CO-OP MINING CO.

BEAR CANYON PERMIT MODIFICATION

The following pages contain the Co-op Mining Company response to the letter from DOGM listing the deficiency in the modifications for the Bear Creek Canyon Mine of Feb. 3, 1983, refered to in a letter of May 2, 1983.

TYPICAL PORTAL SEAL

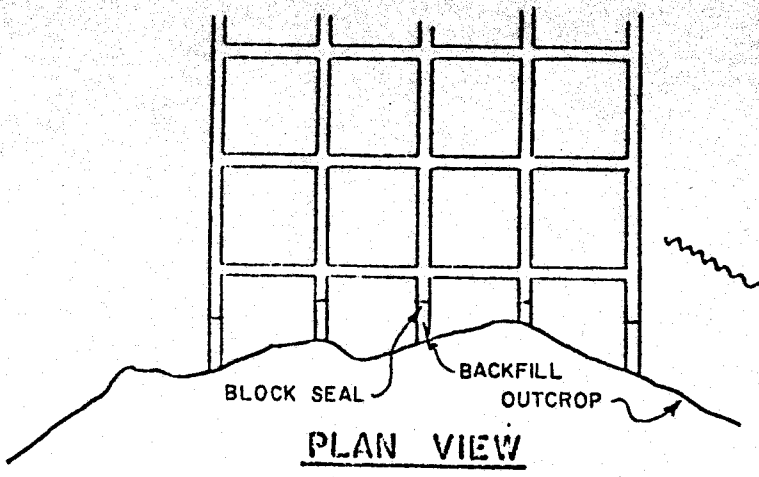
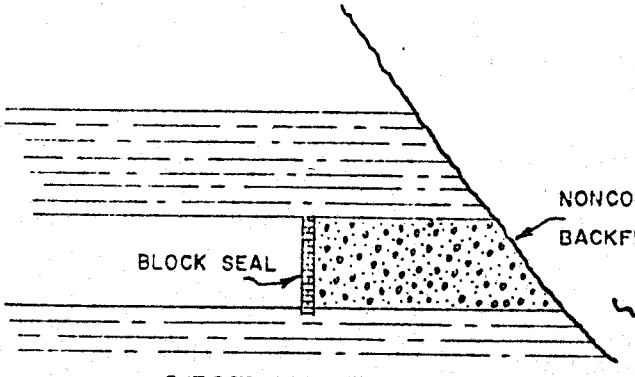
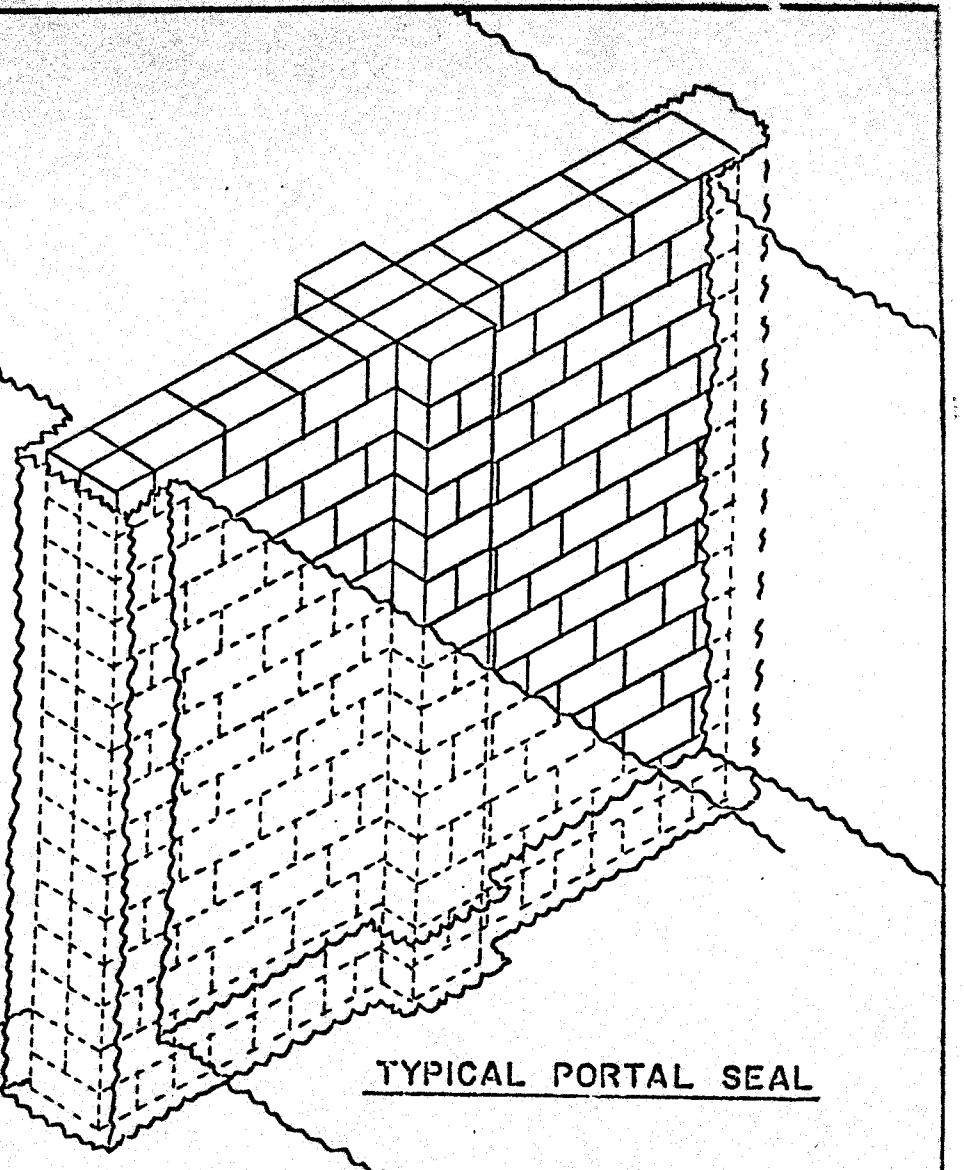
Seals will be installed in the following manner: The seal will be recessed at least 16 in. deep into the rib and 12 in. deep into the floor. No recess will be made into the roof. The blocks will be at least 6 in. high, except in the top course, and 8 in. wide. The blocks will be laid and mortared in a transverse pattern. In the bottom course, each block will be laid with its long axis parallel to the rib. The long axis in succeeding courses will be perpendicular to the long axis block in the preceding course. An interlaced pilaster will be constructed in the center. The seals will have a total thickness of 16 in. Where conditions permit, the portal seals will be graded to conform with existing surface contours and planted. In those instances where sizable highwalls established in preparing the portal site cannot be returned to original contours, the opening in front of the wall will be filled with noncombustible material as above, and the portal and entire exposed seam on the highwall will be covered with 6 to 8 ft. of noncombustible material, graded, covered with suitable material, and seeded. For illustration of a typical seal, see Figure 1.

PLATE 1

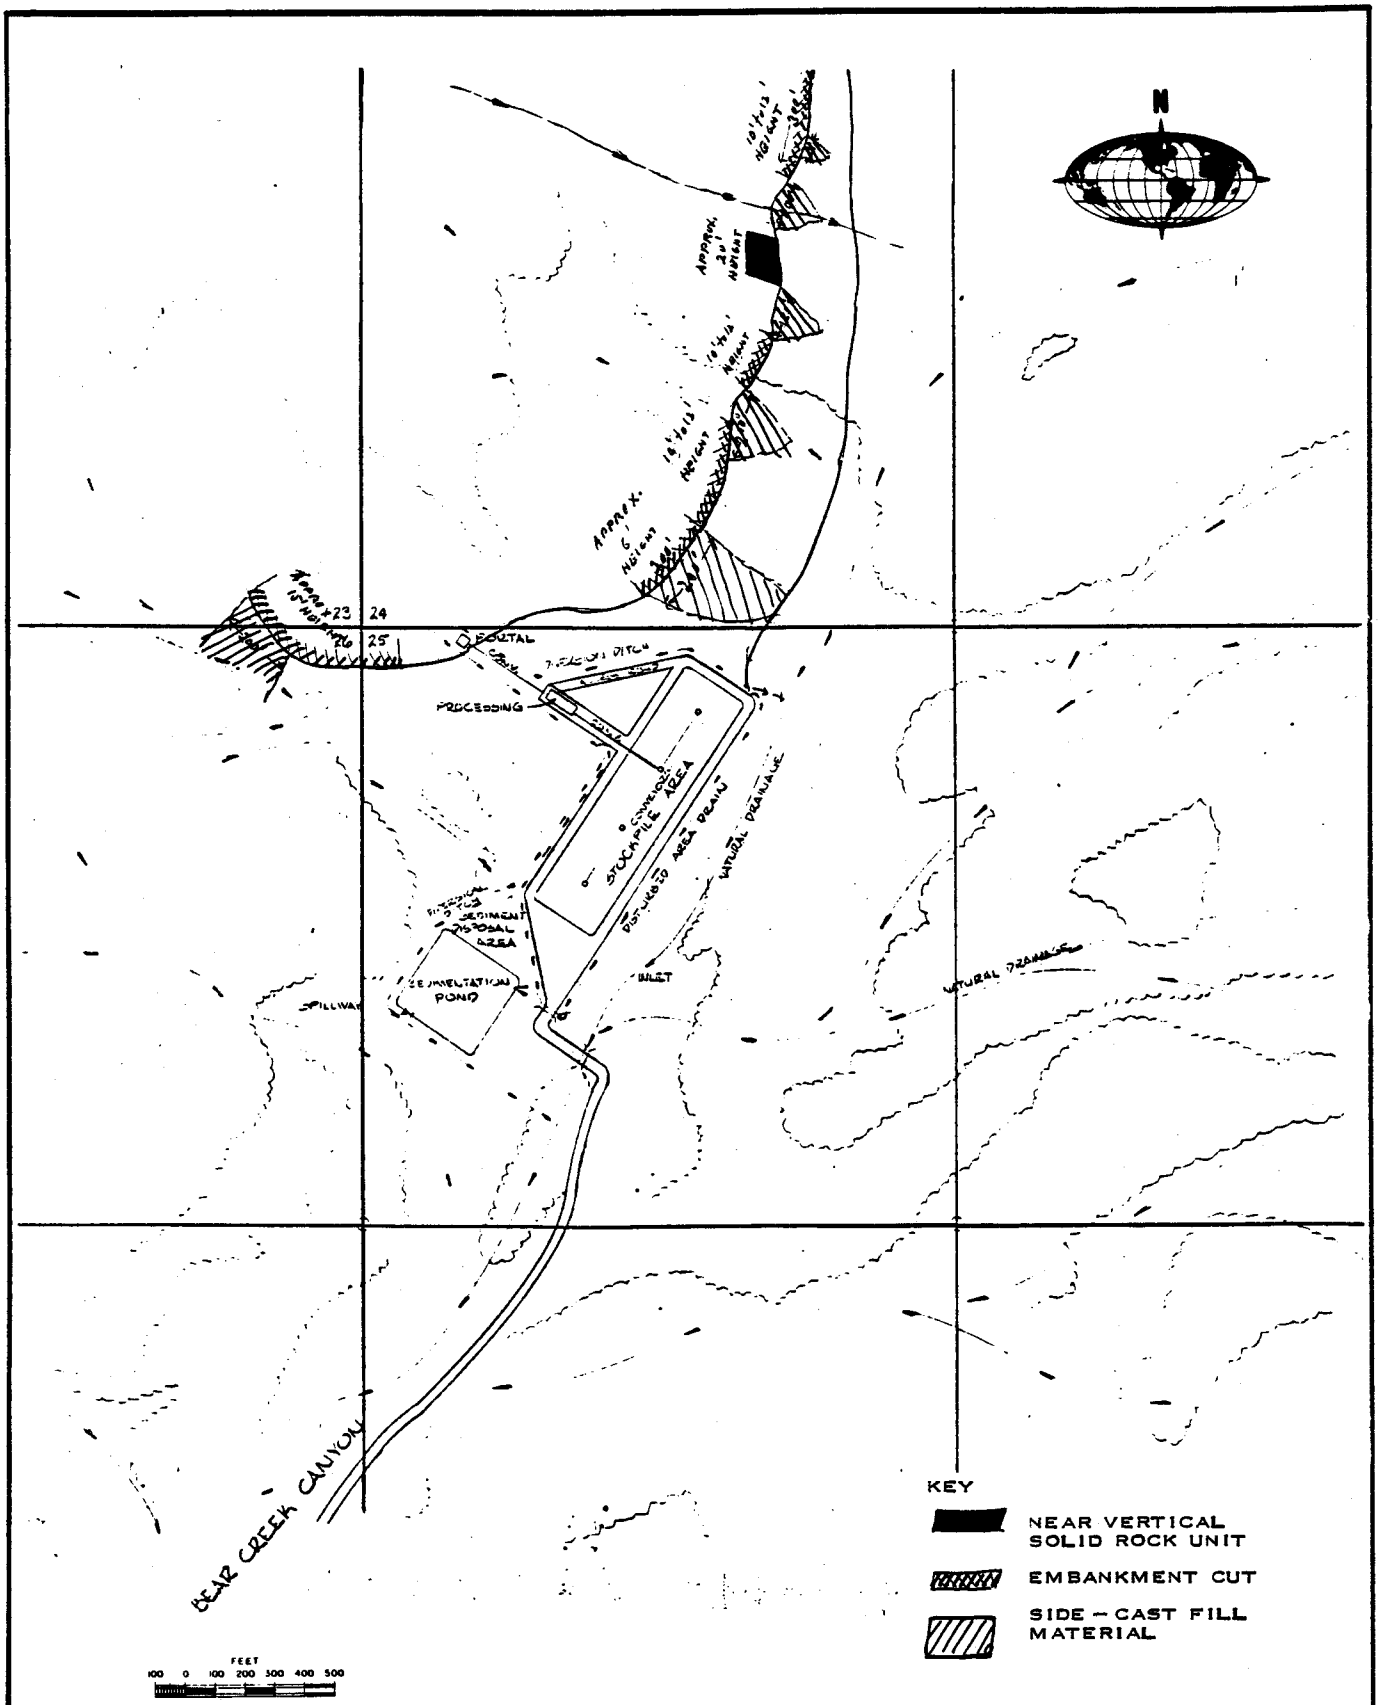
The general location of the Bear Creek Portal Access Road is shown on Plate 1, Plot Plan. Side-cast cut and fill areas as determined by others are also indicated on Plate 1. The slopes in the area of the Bear Creek Portal are generally steeper than 20 degrees and the access road has been constructed by conventional side-cast methods. The material being excavated and forming this side-cast cut and fill typically consists of fine and coarse gravel and cobble sized pieces of silty sandstone in a sandy and silty clay matrix. Calcium carbonate derived from the cement in the sandstone is also present.

Based on our slope stability analysis and observations made during our reconnaissance visit to the site, it is our opinion that the side-cast fill material located along the Bear Creek Portal Access Road generally has a long-term static factor of safety of 1.5 or greater and will perform in a satisfactory manner.

PLATE 2

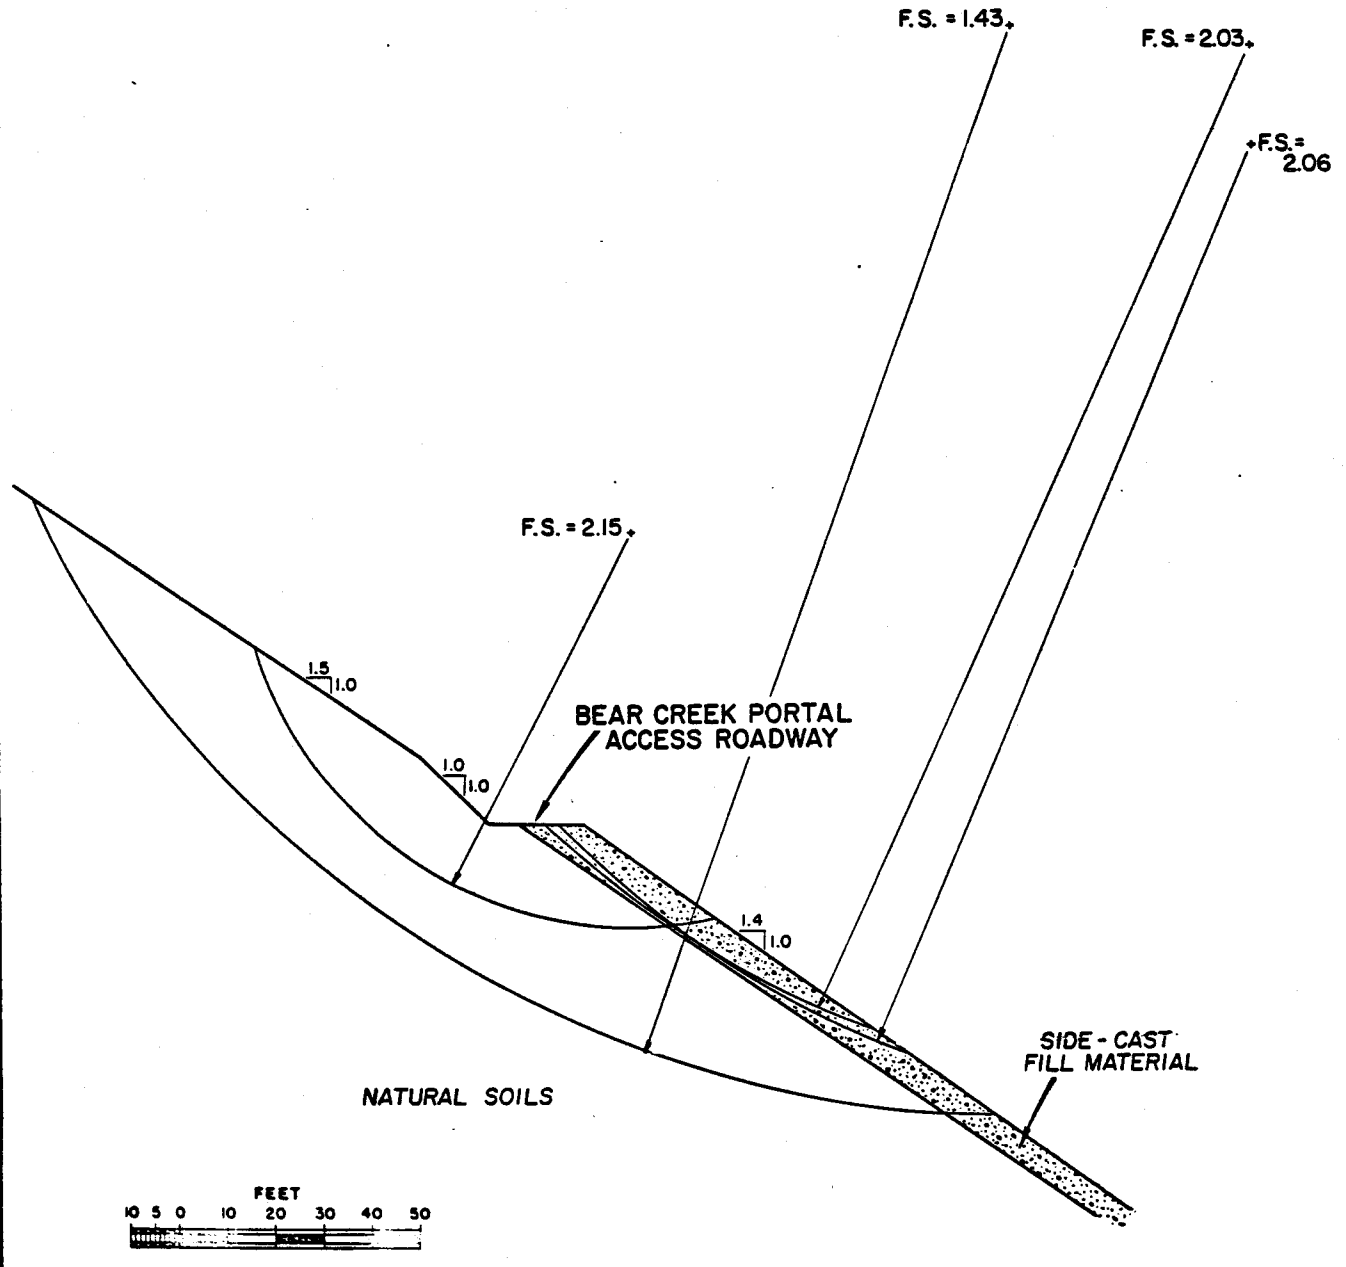
To aid in evaluating the stability of the side-cast cut and fill material of the Bear Creek Portal Access Road, a computer slope stability analysis was performed. The computer analysis utilized a simplified Bishop's Method in computing the long-term static factor of safety of the slopes. Due to the limited laboratory and field data, and the uncontrolled method in which side-cast cut and fill materials are placed, ultra conservative soil strength parameters were used in the computer analysis. A Geometric cross-section of a critical section utilized in the analysis is shown on Plate 2, Slope Cross Section. It was also assumed that a phreatic water surface would not develop in the slopes of the embankment.
